# **Submission on Barangaroo Concept Plan, Amended Mod 9 18.02.24**

From John McInerney, AM LFPIA FRAIA

This letter of advice relates to the concept plan approval *Concept Plan 06\_0162 – Barangaroo* (the 'Concept Plan') and subsequent modifications, as they pertain to the site known as Central Barangaroo. This advice is prepared in the context of the current exhibition of the revised scheme of Modification 9 of the Concept Plan.

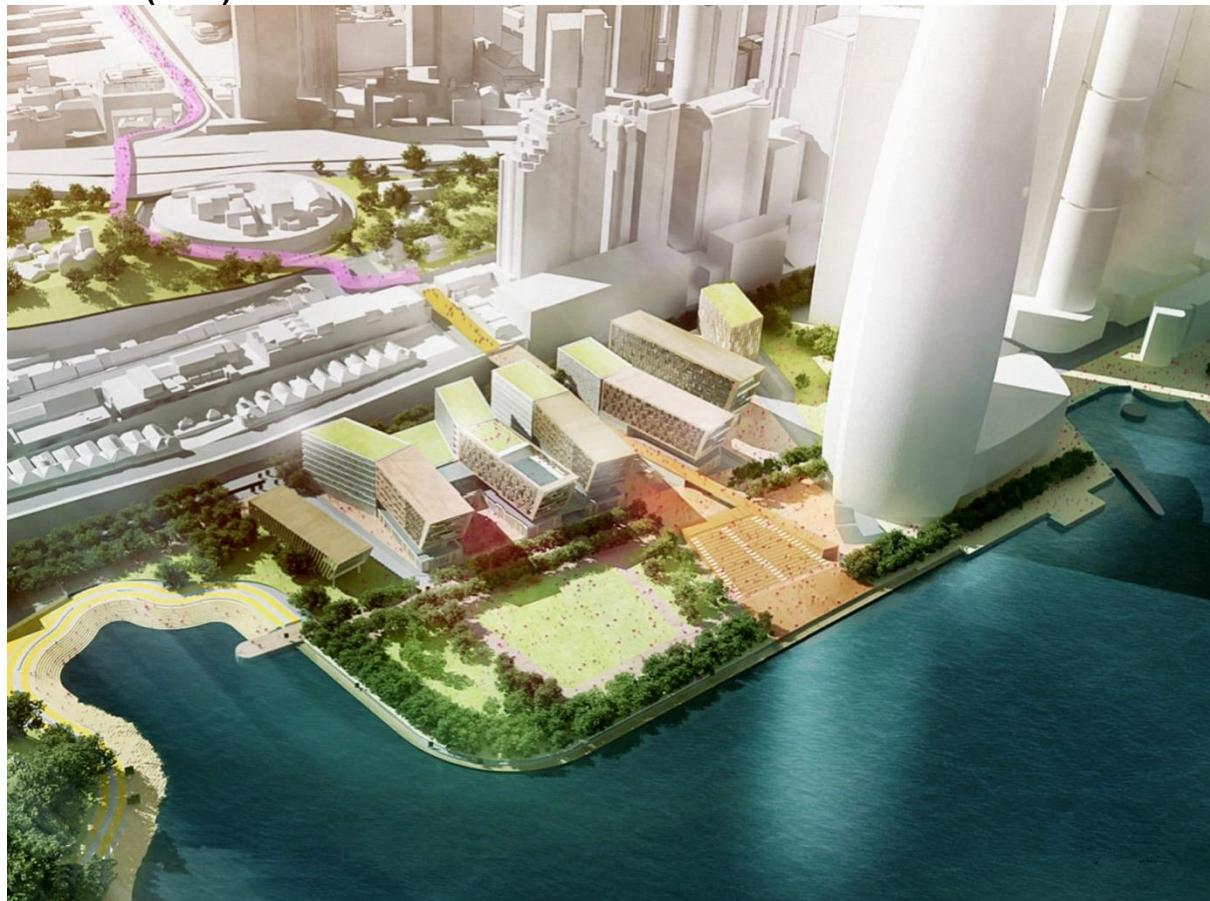
A recommendation of the recent Select Committee on Barangaroo Sight Lines was that a View Management Strategy must be developed in consultation with Heritage NSW and the City of Sydney

**Figure 11: Mod 9 Proposed Building Envelope with RLs.** (Source: *Central Barangaroo Urban Design Report and Design Guidelines*, prepared by SJB, 28 November 2023).

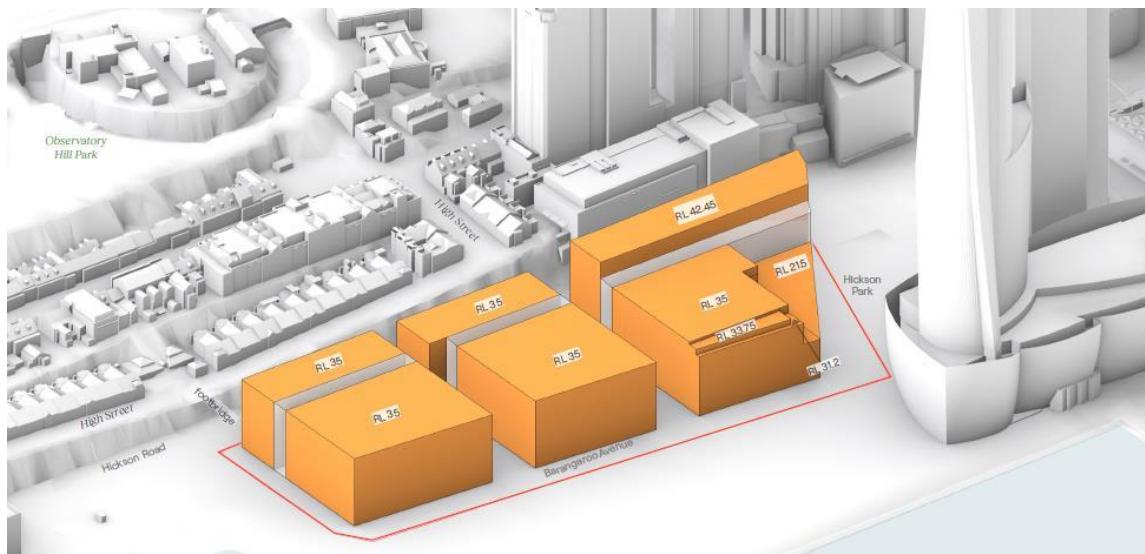
Our analysis concludes that the representation of the approved building envelope supplied by Modification 9 is erroneous and misleading. As detailed in our analysis, the built form at Central Barangaroo was always intended to feature a 'reduced form of development', where built form would transition in scale to the adjacent Headland Park and a design of varying building heights would deliver significant east-west view corridors to *"protect and enhance the surrounding townscape and views"*.

- Extending the southern boundary of Block 5 further south to encroach into land zoned RE1 Public Recreation.
- Amending the maximum height of buildings within each development block

• Introducing a maximum GFA allocation for all of Central Barangaroo of 104,000sqm (11,908sqm of which is proposed to be below existing ground level).
